Agenda  
Village of Arlington Heights  
Design Commission  
Virtual Meeting

**Item:** DC#21-004 - 607 W. Maude Ave - SF/Teardown

## STAFF DESIGN COMMISSION REPORT

**Project Name:** 607 W. Maude Ave.  
**Project Address:** 607 W. Maude Ave.  
**Prepared By:** Steve Hautzinger

BASEMENT / FOUNDATION PLAN

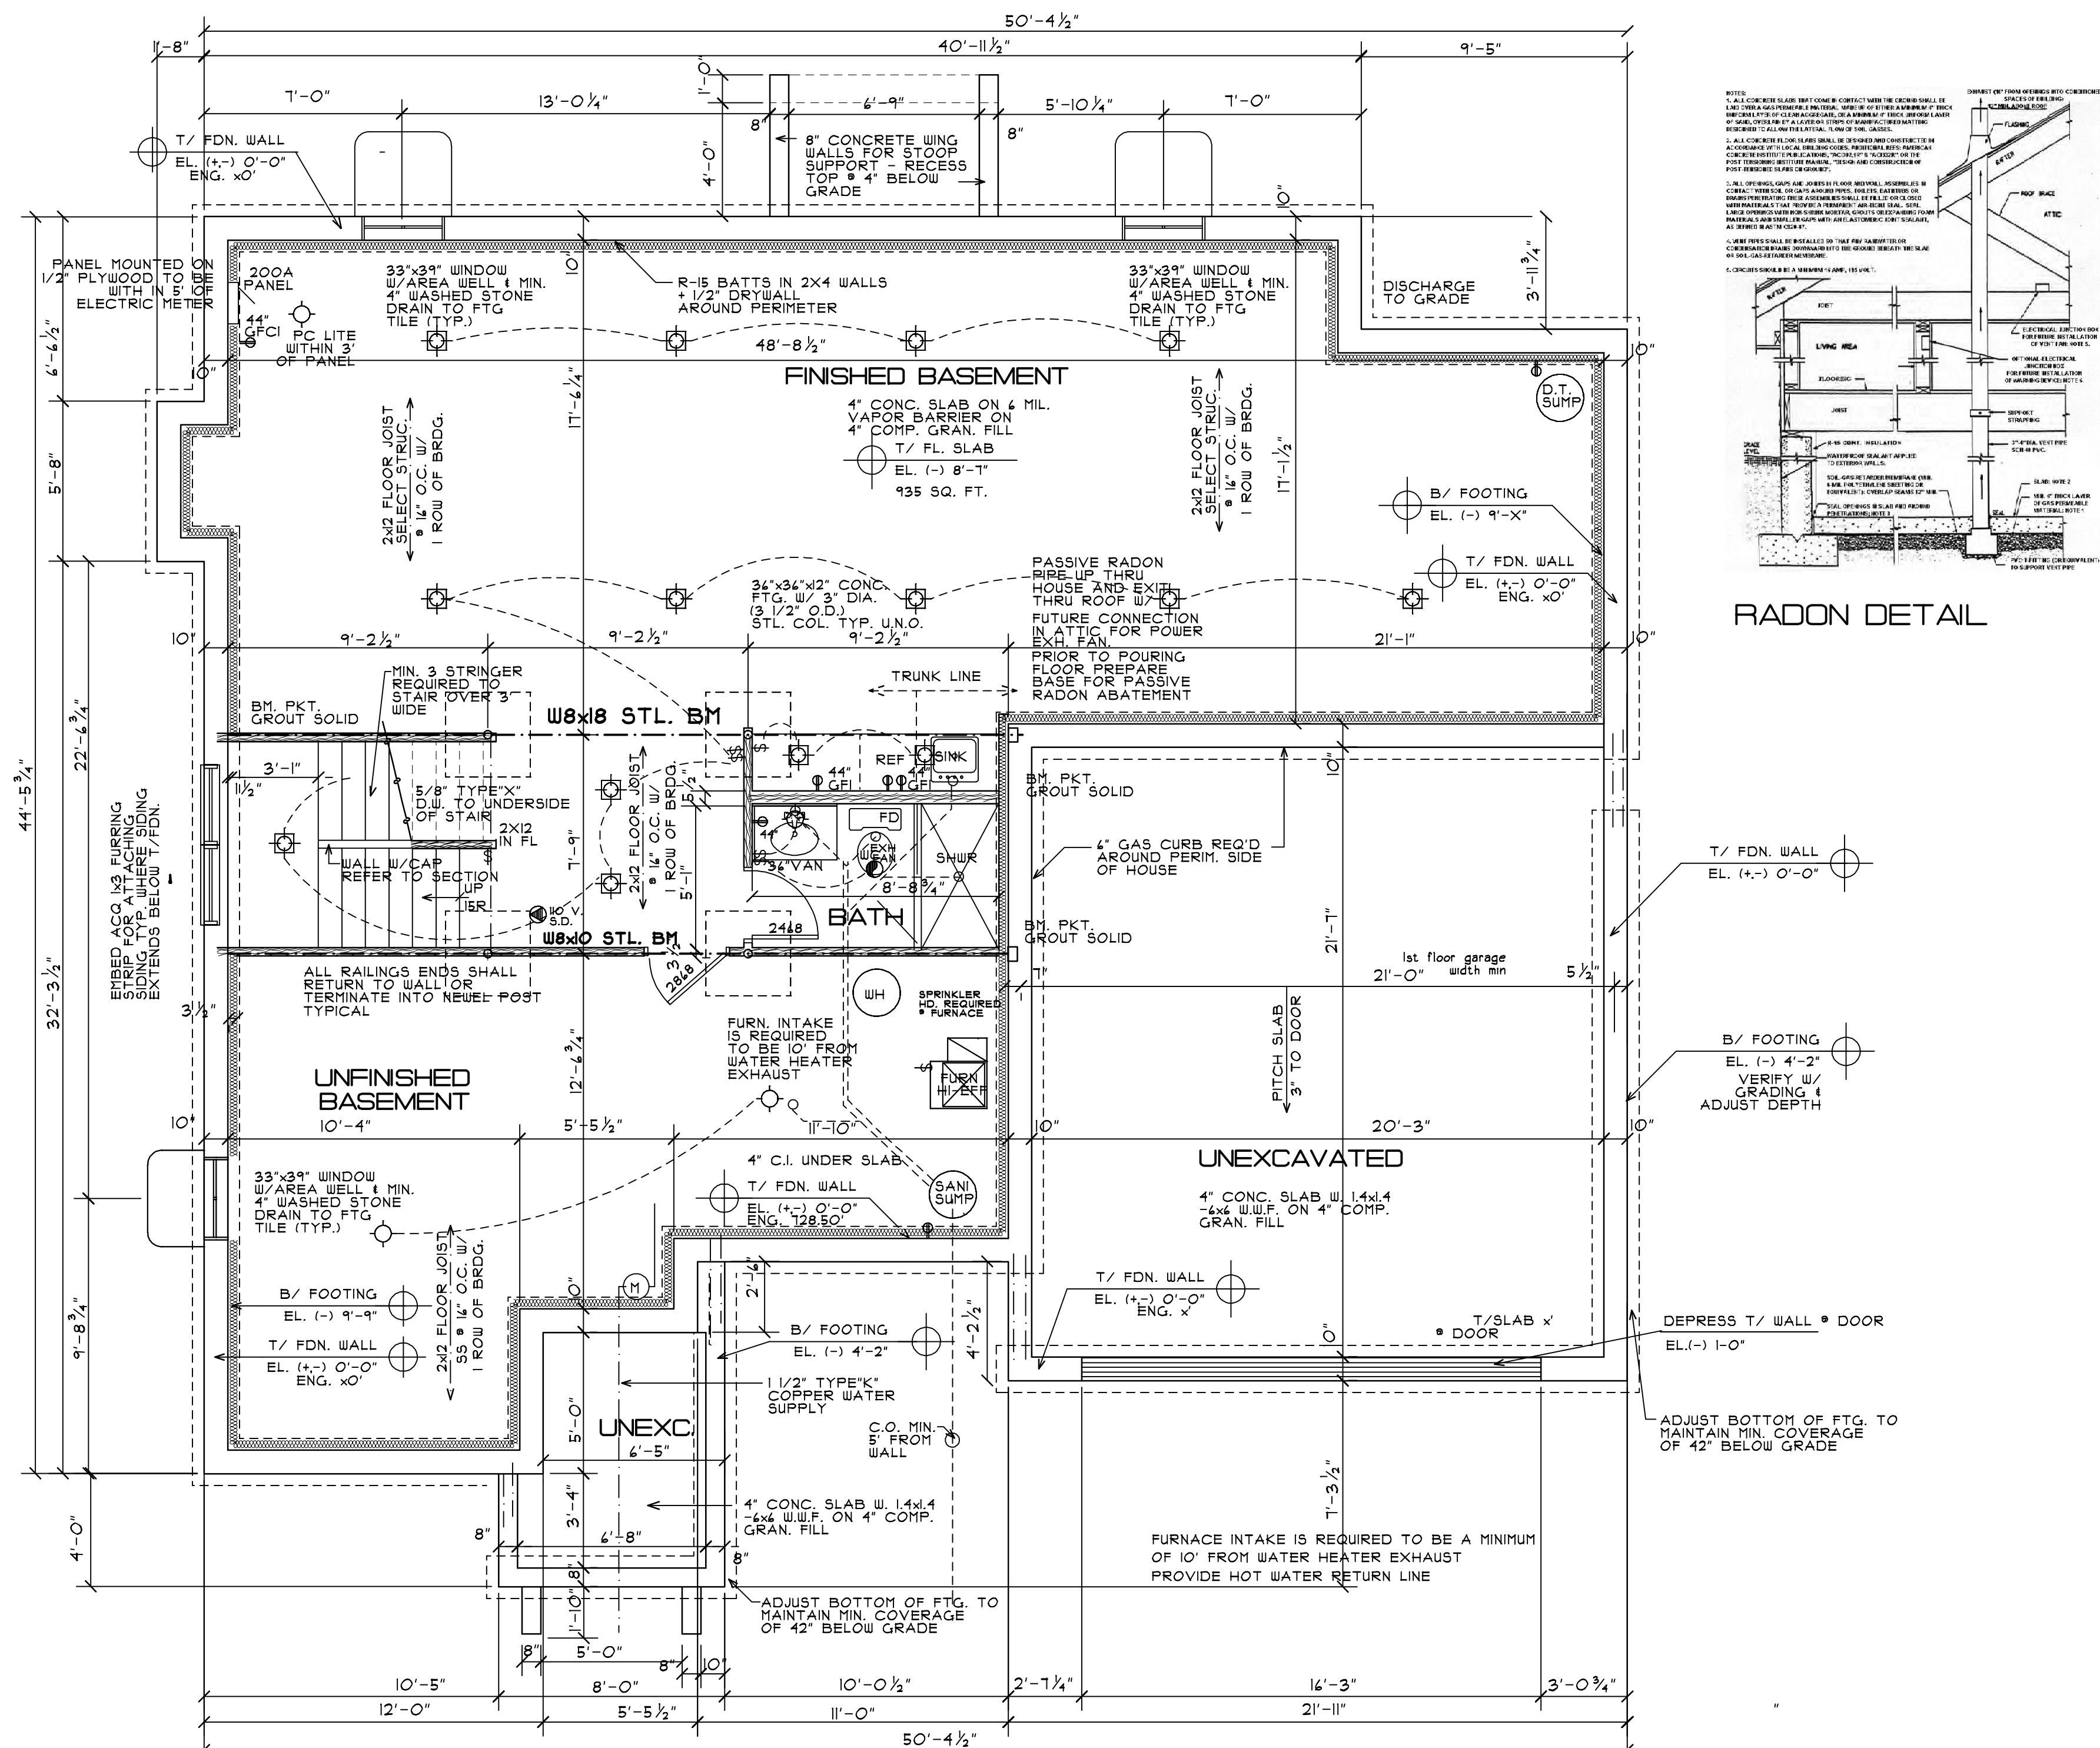
ADDITIONAL COMMENTS:

1. The State of Illinois requires all firms to be registered as design firms. This is in addition to all licensing requirements for individual architects and other design professionals. Revise the cover sheet to indicate the design firm registration numbers for all of the design firms. If you are referring to the only other design firm for this project, Bono Consulting, design firm # 8/4 007319.

2. Provide manufacturer's cut sheets for the emergency escape window in the basement.
  3. Provide manufacturer's cut sheets for the full height of the emergency garage door.

4. Provide a copy of the roof truss drawings, calculations and layout. Section IRC R802.0.1.
  5. The structural elements of the garage shall have 5/8-inch type X gypsum.

6. The second floor joists shall be at least 2x10 over the garage door opening sufficient for the span. Therefore, revise the plans to provide a properly sized beam. Section IRC Table R802.5(1).

7. The second floor joists shall have a drip pan under the unit with condensate line to the floor drain.
  8. The address numbers shall be at least 4 inches in height and over the front entrance.

9. The shelves shall have a minimum rating of Class C or better.
  10. A fire barrier shall be sealed with compatible gaskets.
  11. The CFM's of the kitchen exhaust hood will be less than 400 CFM, otherwise, an integrated make-up air system, designed to meet the kitchen exhaust hood's requirements, shall be provided.

12. A signed, sealed and dated Architect's letter would otherwise be required.
- Electrical**
1. The receptacle at the panel shall be GFCI.
  2. 1/2-inch plywood shall be installed between the panel.

3. The service entrance conductors shall be copper and THW or THHN insulation.
  4. The proper 3/4" working clearance shall be provided for the air conditioner disconnect switches.

5. The GFCI receptacle in the garage shall be at least 48 inches above the floor.
  6. The GFCI receptacle at the second floor furnace room.
- Engineering**

1. The proposed top of foundation and finished garage floor elevations are almost a foot higher than the existing home foundation. The proposed top of foundation must be placed at the average elevation between the home foundations on each side of this lot (approx. 121.3').

2. The proposed driveway slope approximately 10% exceeds the maximum slope guidelines. Reducing the top of foundation elevation mentioned above will positively affect this situation.

- Plumbing**
1. Plumbing registration as State of Illinois has expired.
- Design Commission**
- Per the Design Commission approval, it is required that the 8/4 unit in the side yard be screened with evergreens.
